### **MULTIPLE HYDRANTS FAIL TO MEET REQUIREMENT ALONG THE ENTIRE WEST SIDE OF THE CITY WHICH HAS RECENTLY BEEN IDENTIFIED AT INCREASED RISK OF WILDFIRE!**

### **CONFIDENCE IN THE STUDY FINDINGS ARE IMPORTANT – REASONS FOR DOUBT?**

# Local Responsibility Area Fire Hazard Severity Zones

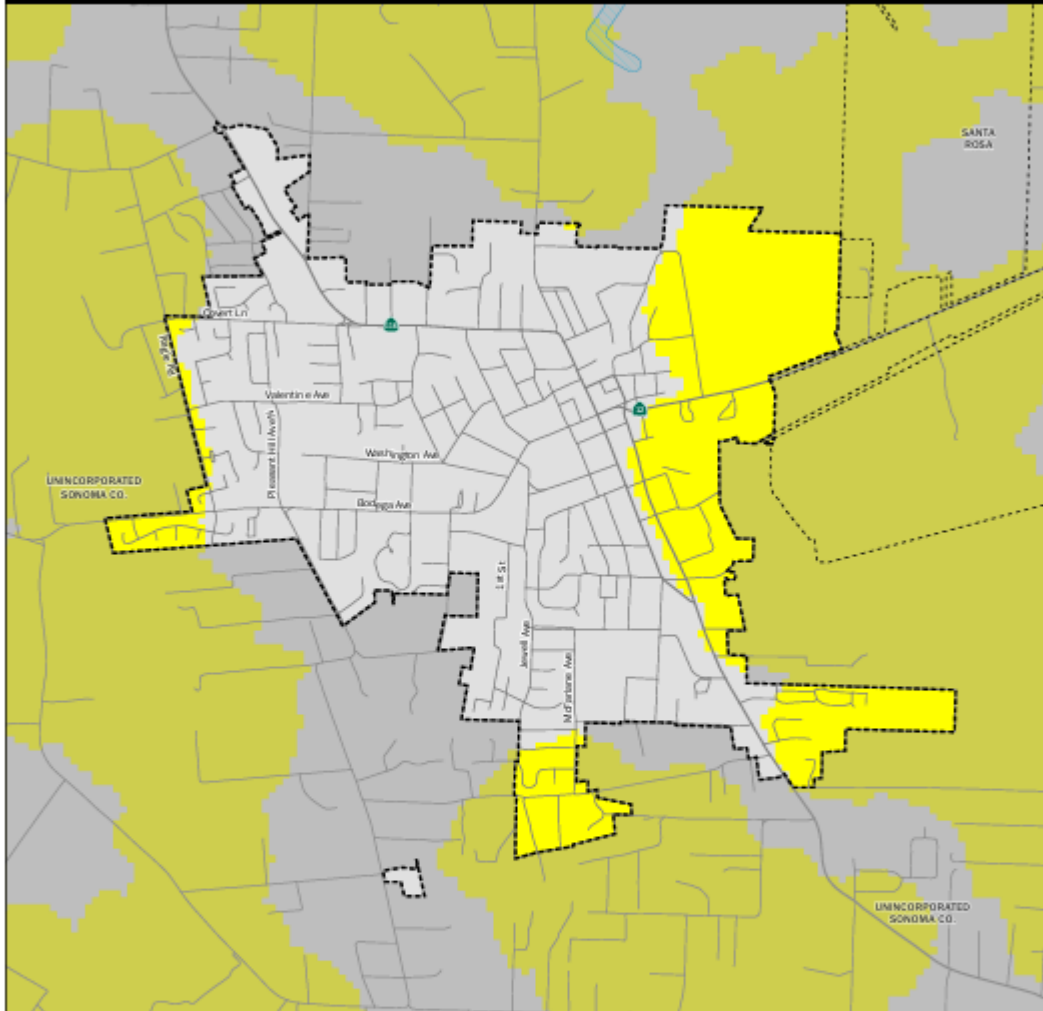
The western border of the city was identified as moderate for wildfire risk (See map below). Looking at Figure 13, the majority of the hydrants operating at less than required flows\* are distributed along the western border of the city where there is higher wildfire risk.

Second note the fire risk on the south side of the city. Although only the area within the city limits is identified, the fire risk is obviously more widespread. Note that the locations of our

storage tanks are all within 2,000 feet of the identified hazard area. It is likely that the Pleasant Hill tanks are located in the wildfire risk area and at the top of a hill.

Figure 13 Available fire flow at 20 psi under the existing MDD+FF condition.

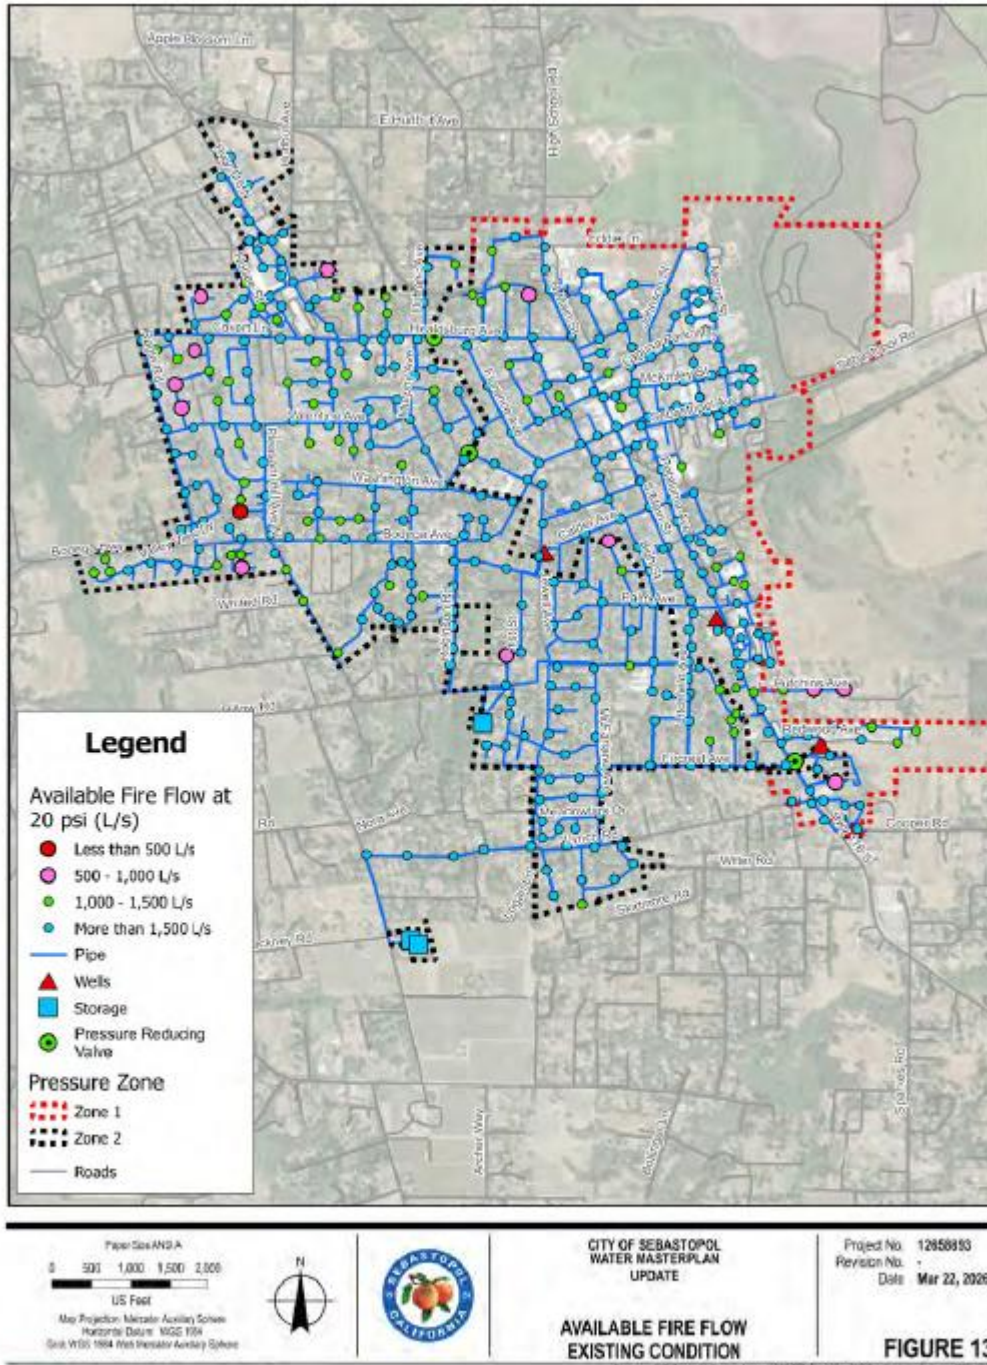
(\*Note: the text describes hydrants that are based on a model below 1500 GPM at 20PSI. The map offers labels for <500 L/s, 500-1000 L/s and more than 1500 L/s. Switching from GPM to L/s is confusing. Particularly confusing because 500 L/s is actually 7,925 GPM. This is nonsensical so I am assuming that the chart label should be GPM and not L/s.)

The study has basic issues that suggest there has not been a careful review of the document. Many of the references to figures include an error message. More critically the map of hydrants with lower than required flows is mislabeled L/s rather than GPM.
